SEDGWICK COUNTY, KANSAS
DIVISION OF FINANCE
Purchasing Department
Iris Baker, Purchasing Director

REQUEST FOR BID
#09-0059
EXPANSION OF THE FORENSIC SCIENCE CENTER
1109 N. Minneapolis, Wichita, KS
Addendum #2

April 13, 2009

SECTION @ FOUNDATION

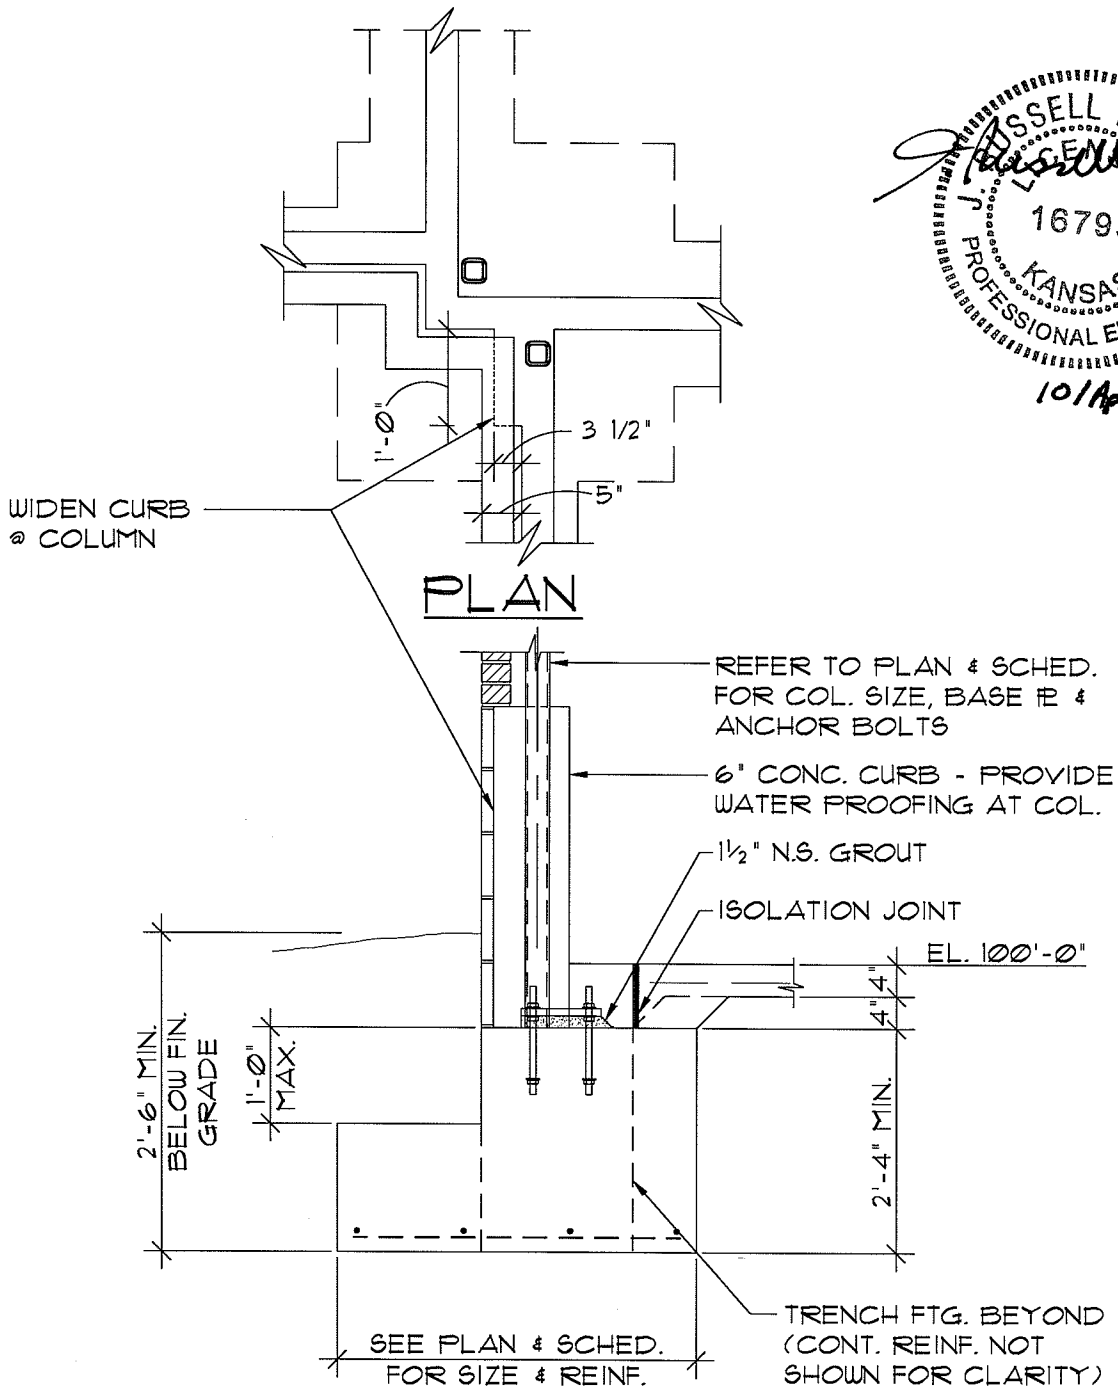
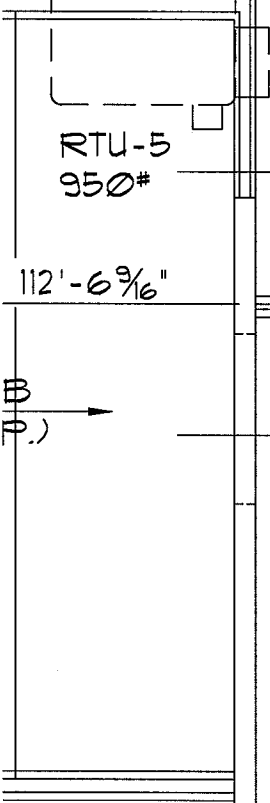
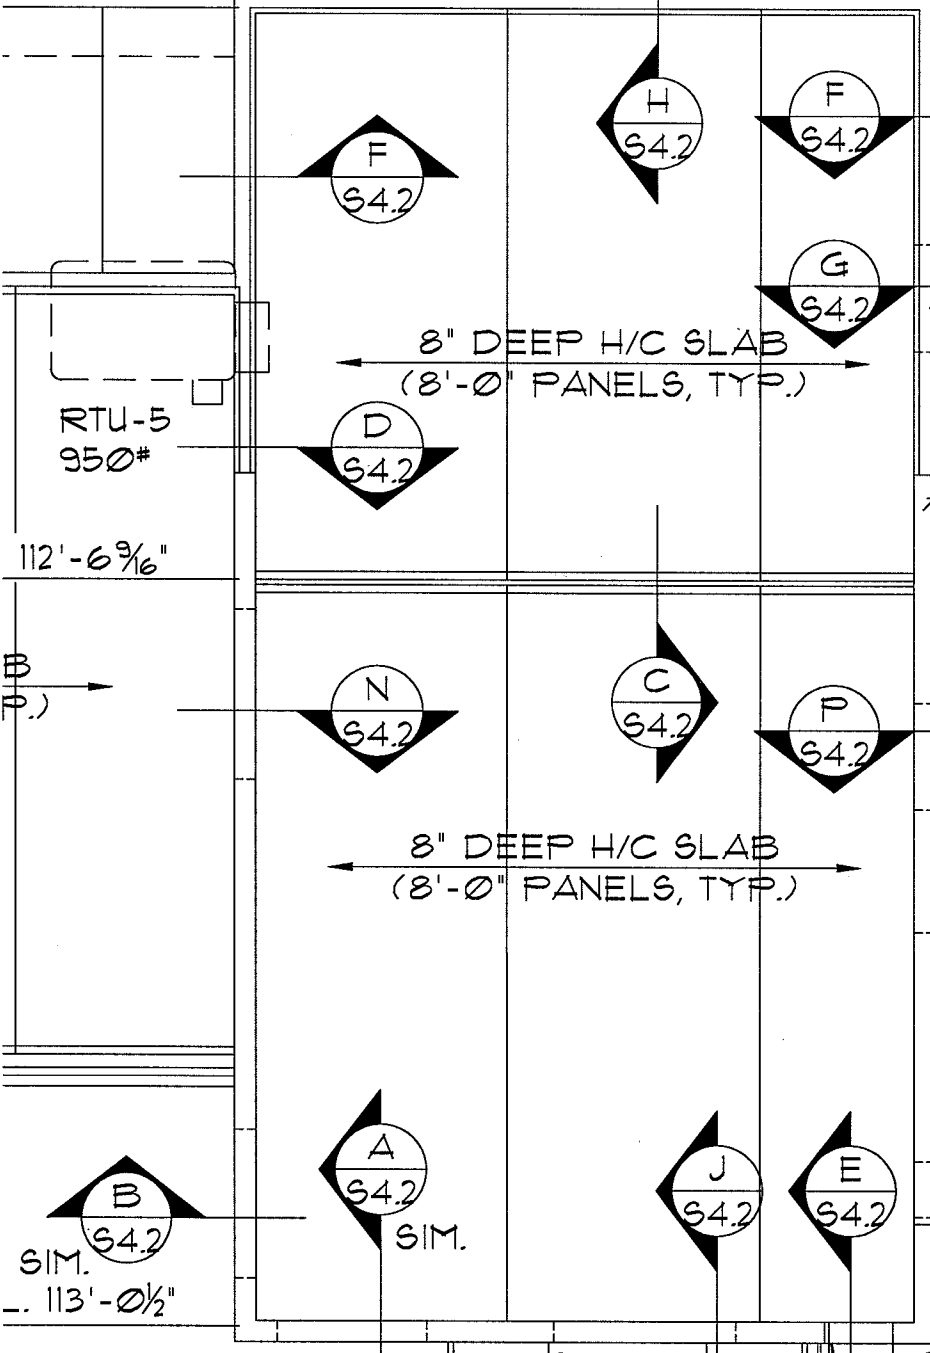
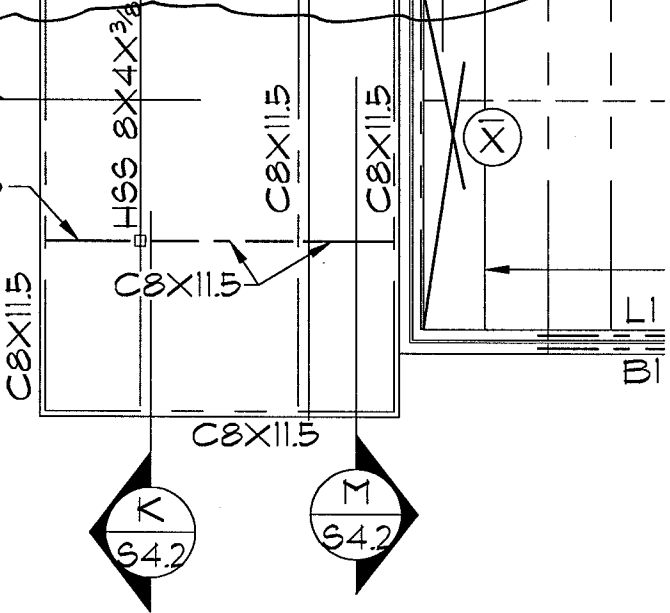
- 6. Details D/S5.1 and E/S5.1 have been corrected and are attached. The 6" concrete wall will extend to 32" above finished floor (102'-8"). Concrete wall will bump out at the column and cut faces of block will be veneered onto the bump out to match face of wall.**

P SECTION @ ROOF
S4.2

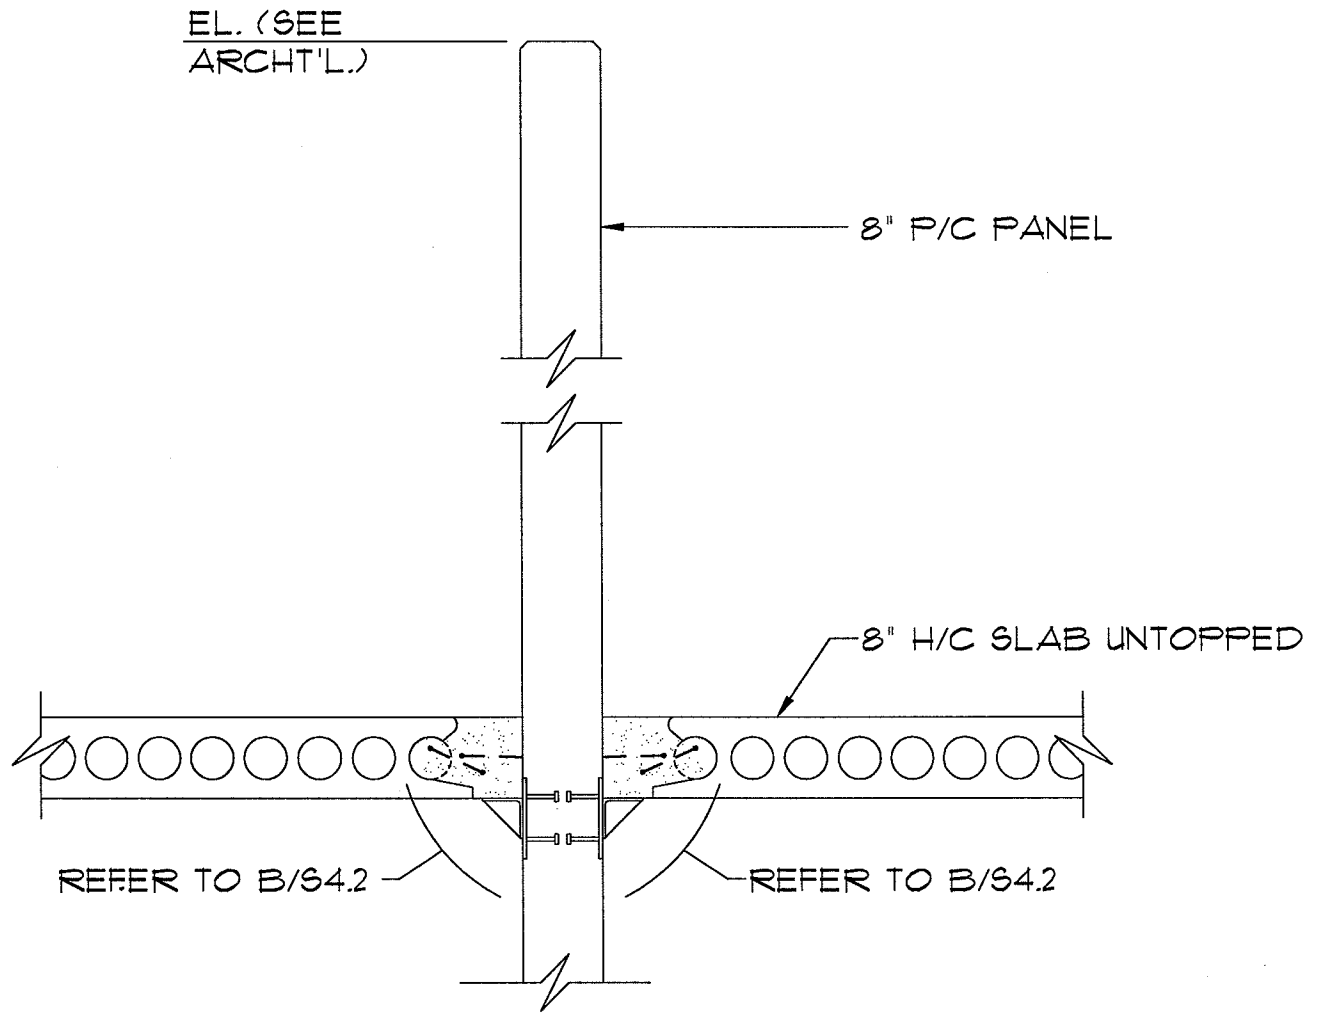
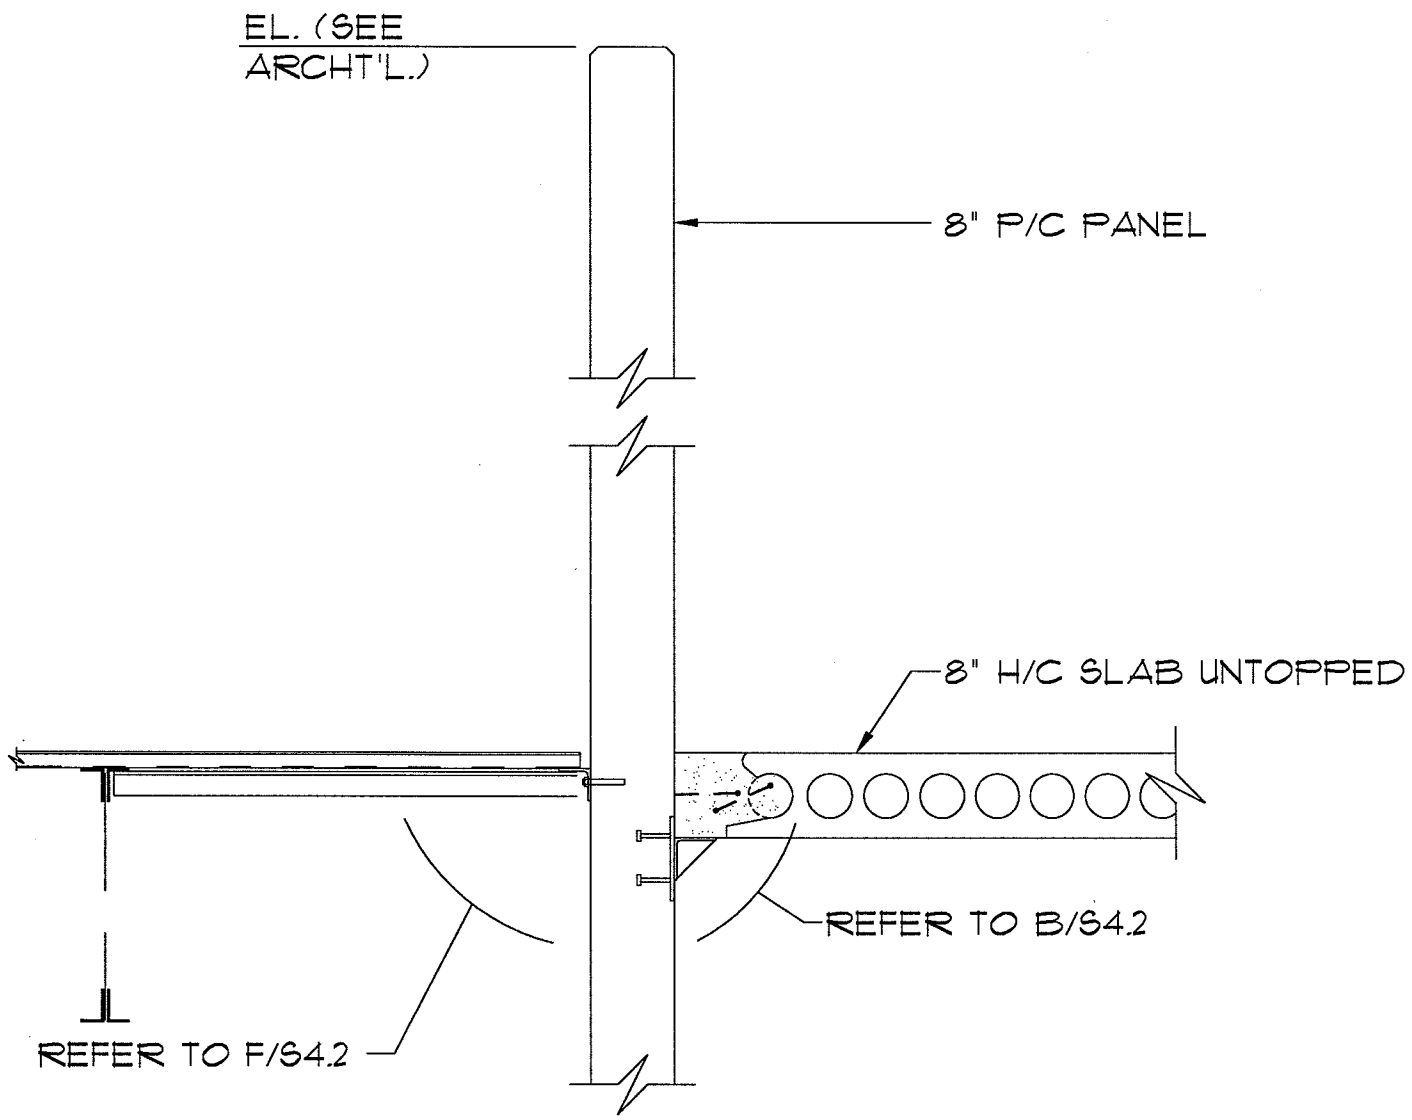
11. **Architectural drawings indicate some of the precast walls at the evidence processing room #138 go up to elevation 120'-4" to create a parapet condition, but the structural details show hollow core bearing on top of those walls. Please clarify. Drawings 'Partial S2.1, Detail N/S4.2, and Detail P/S4.2' are provided for clarification to the precast connection details at the roof above Evidence Processing #138.**
